RE: GRADING PLAN FOR SHENANDOAH UNIT 3 LOTS 37-43 (D-11/D10A)
RECEIVED OCTOBER 27, 1993 FOR PAVING PERMIT APPROVAL
ENGINEER'S STAMP DATED 10-27-93

- Notes to the October, 1993 revision of grading/drainage plan for Lots 37 - 43, Unit III of Shenandoah Subdivision.
- The December, 1985 Drainage Management Plan for Shenandoah, Units II and III, prepared by Community Sciences Corporation was the basis of the initial grading and drainage plan; said plan serving as the basis of this revised grading plan for Lots 37 - 43 of Unit III.

TITLE: SHENANDOAH - UNIT 3
GRADING PLAN

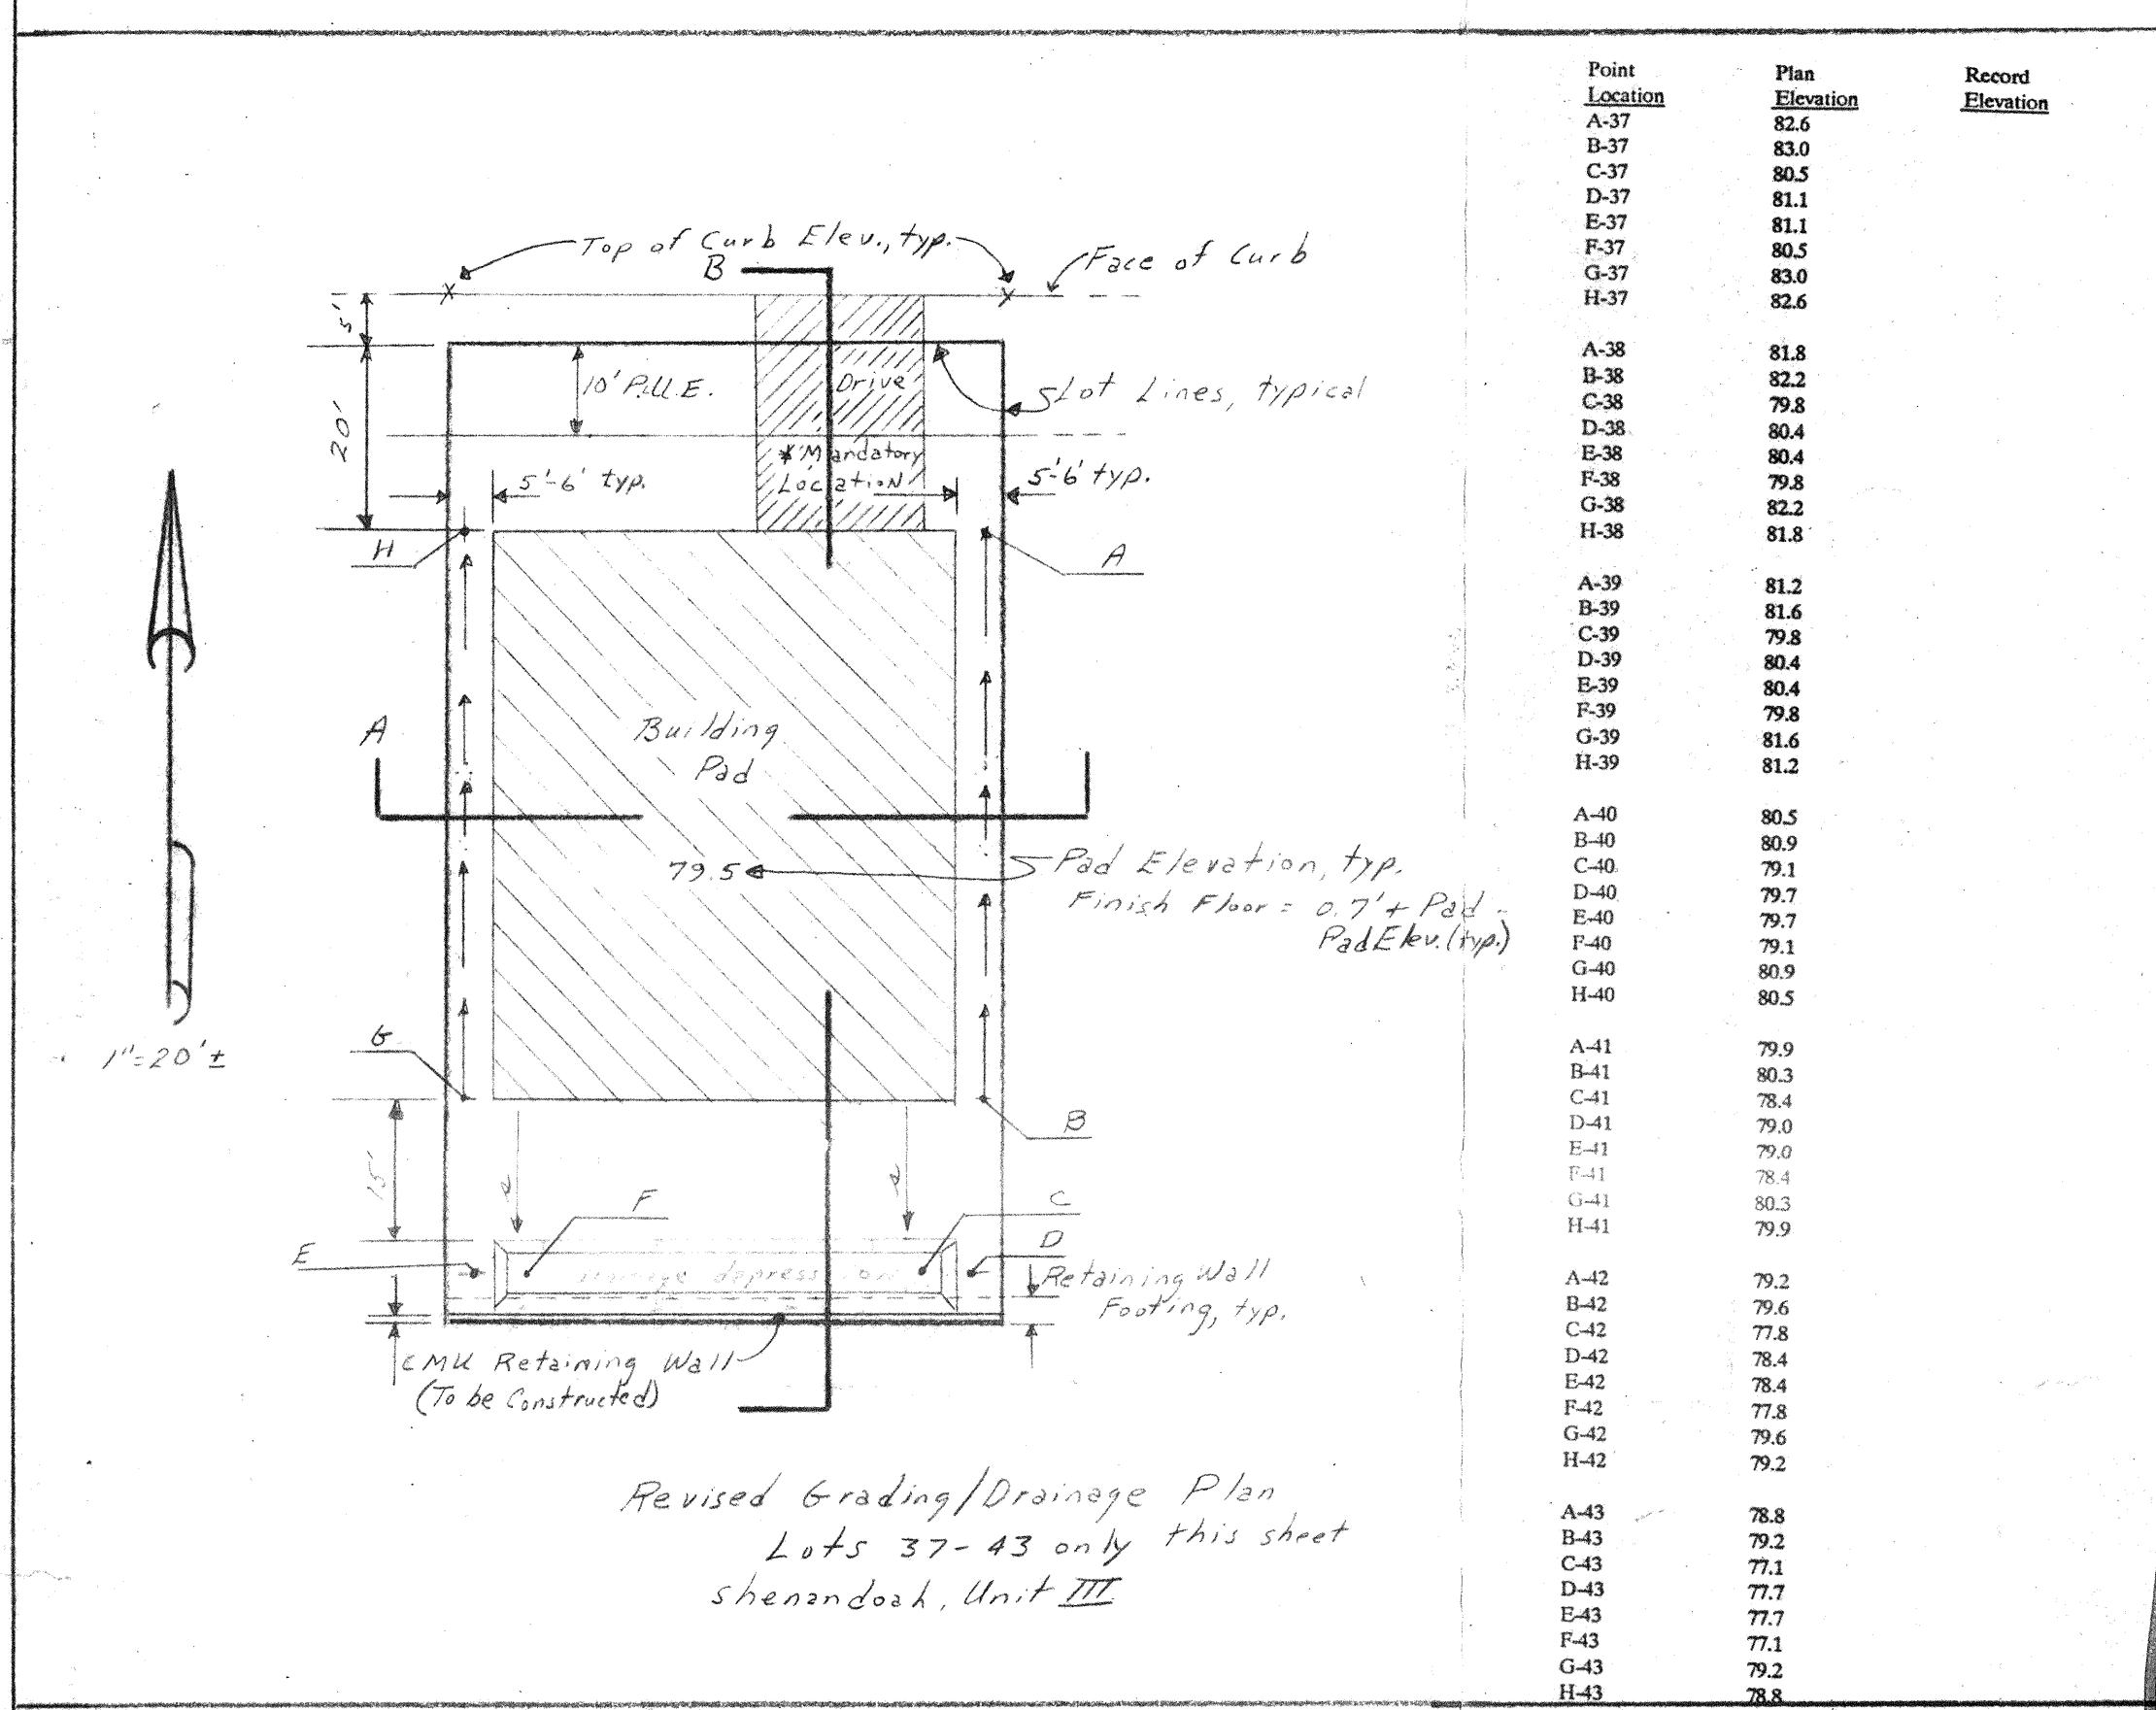
1. Provide additional spot elevations for each lot at the bottom of the depression, at the top of the depression, at the upstream and downstream invert of the swale on both sides of the building pad and the top of curb adjacent to each property corner. These elevations should be presented in a format compatible with the DPM checklist for Engineer's Certification.
2. Provide additional spot elevations for Lot 93 at the pad and along the common border with Lot 43.

- Changes to the original grading plan consist of the following:
 - The pad grade for Lots 37 - 43 have been lowered from 0.3 feet to 0.7 feet.
 - A retaining wall is placed along the southerly property line for Lots 37 - 43, the wall height ranging from 2.8 feet at Lot 37 to 8.0 feet at Lot 43.

- The point of drainage flow change was relocated from the center of building pad to the rear of the building pad and a rear yard drainage depression was included, these items included as a result of a pre-design meeting with city hydrology staff.
